SYSTEM/MODEL: NEM

MODIFICATION: Lengthen time between rings on master (incoming call)

LENGTHEN TIME BETWEEN RINGS ON MASTER (During incoming call)

NEM Main PC Board Schematic Diagram

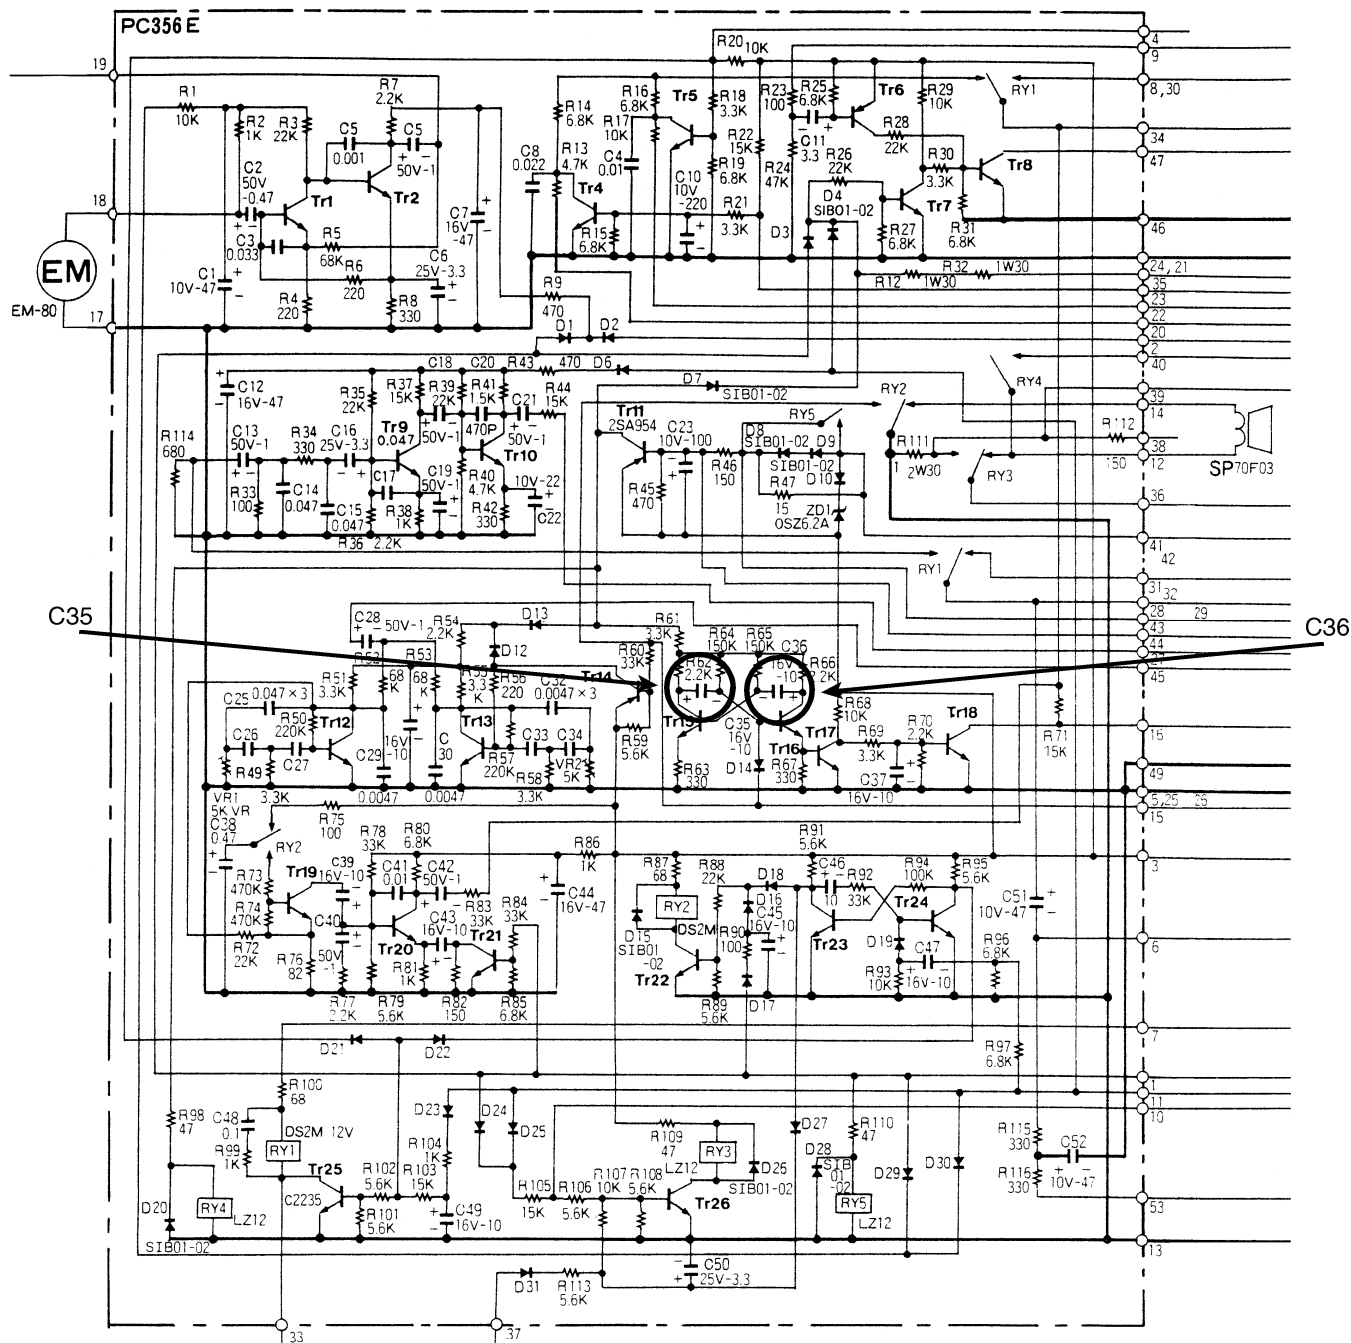
- INSTR/OPERATIONS:**
1. Locate and change value of capacitor C36 to 47 mfd., 16V or higher.
 2. If the length between rings isn't long enough, locate and change value of C35 to 47 mfd., 16V or higher.

Change value of C36 to 47 μ fd., 16V.
If necessary, change C35 to 47 μ fd., 16V.
